**Q-6: Review Agency Comments on Draft
Environmental Study Report**

Agency Comments on the Draft Environmental Study Report and Project Team Responses

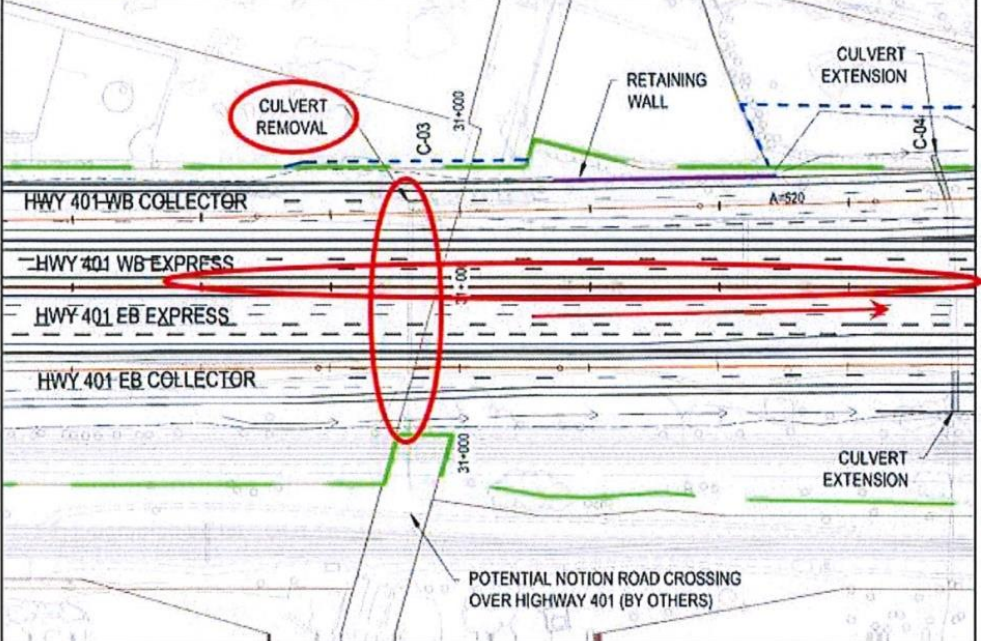
7	<p><i>Preliminary General Arrangement</i></p> <ul style="list-style-type: none"> a. Clearly show Metrolinx Right-of-Way (Property Limits) with dimension; b. Include Mileage and Subdivision on all Drawings showing Metrolinx Railway Corridor (i.e. Mile 2.45 GO Subdivision); 	<ul style="list-style-type: none"> a. As previously discussed with Metrolinx, it has been confirmed that the GO / Metrolinx Lakeshore East rail line is within MTO controlled ROW and Metrolinx does not own lands within the Study Area. b. Comment noted to be addressed in detailed design. 	Appendix N
8	<p><i>Preliminary General Arrangement</i></p> <ul style="list-style-type: none"> a. We require the following notes to be included as "Metrolinx General Notes" on the Contract Drawings: <ul style="list-style-type: none"> i. Design is in accordance with current versions of AREMA Manual for Railway Engineering, Metrolinx General Guidelines for Design of Railway Bridges and Structures and GO Transit Design Requirements Manual, as required; ii. Prior to commencing any work within, over, under, or adjacent to the Metrolinx Right-of-Way, the Contractor shall apply for and receive a Metrolinx Work Permit; (1) When submitting the Work Permit Application(s), the Contractor shall allow for sufficient time for Work Plan review, revision, and Track Block coordination; iii. The Contractor shall conform to the Metrolinx Work Permit and submit all required information for review and acceptance (from the Contract Administrator and AECOM / Metrolinx); iv. Work within / over / under the Metrolinx Right-of-Way shall be performed under Railway Flagging Protection; (1) At the discretion of AECOM / Metrolinx, Railway Flagging Protection may also be required for work adjacent to the Metrolinx Right-of-Way; v. At the discretion of AECOM / Metrolinx, it may be required to complete certain construction activities outside of Railway Service Hours (i.e. certain works may be restricted to overnight or weekend hours) as applicable; (1) Allowable hours of work are dependent on the task and proposed work methodology and will be confirmed by AECOM / Metrolinx after review of the Contractor's Work Permit Application and associated Work Plan Methodology; (2) Track Block requests shall be submitted a minimum of four (4) weeks in advance of the proposed work and are subject to Metrolinx approval; (3) Any request for Major Track Closures (i.e. closure of all Metrolinx Tracks) shall be submitted a minimum of twelve (12) weeks in advance of the proposed work and will be subject to Metrolinx approval; (a) Workblock and Track Protection Request Forms 	<p>The Metrolinx General Notes are noted for consideration in detailed design and inclusion on contract drawings and in the tender documents as appropriate, in consultation with Metrolinx. Further discussion is required during detailed design with regards to detailed staging plans.</p>	Appendix N
